SAKURA EAST PRO

FORMAL PRO CONCEPT PLAN
July 30, 2024

PRELIMINARY SITE PLANS

SAKURA EAST

P-2

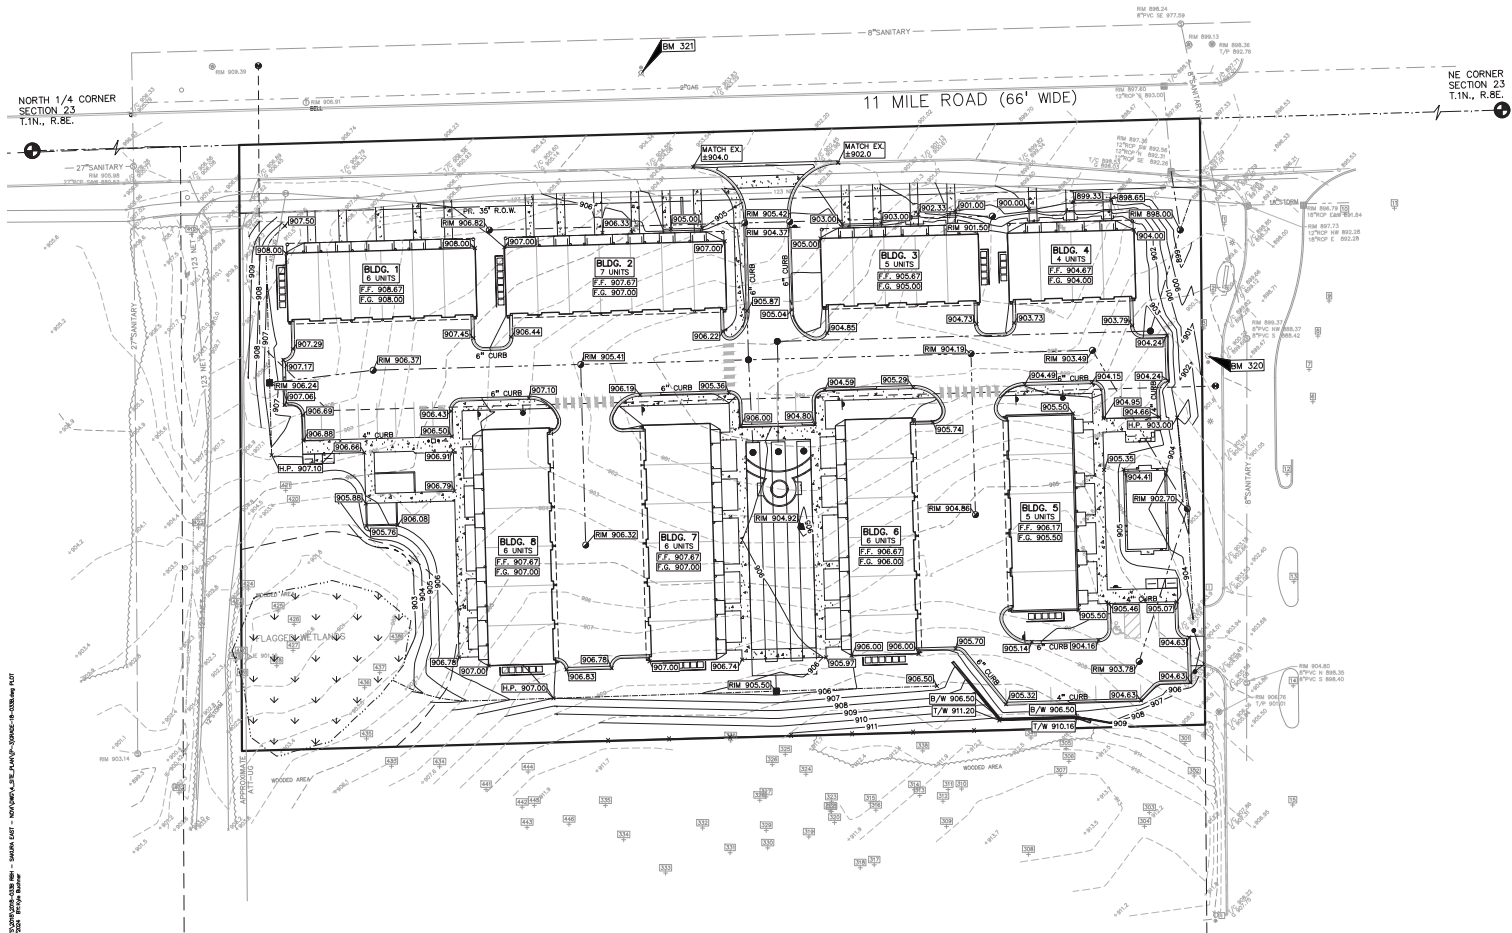
- a. An in-depth explanation of the need for a Wetland and Watercourse Setback can be found on page 3-67 of the [City of Novi Zoning Ordinance](#).
 - b. No impacts are proposed to the on-site Wetland. However, impacts appear to be proposed to the 25-foot Wetland Setback. Sheet P-2 shows a small portion of concrete sidewalk will be
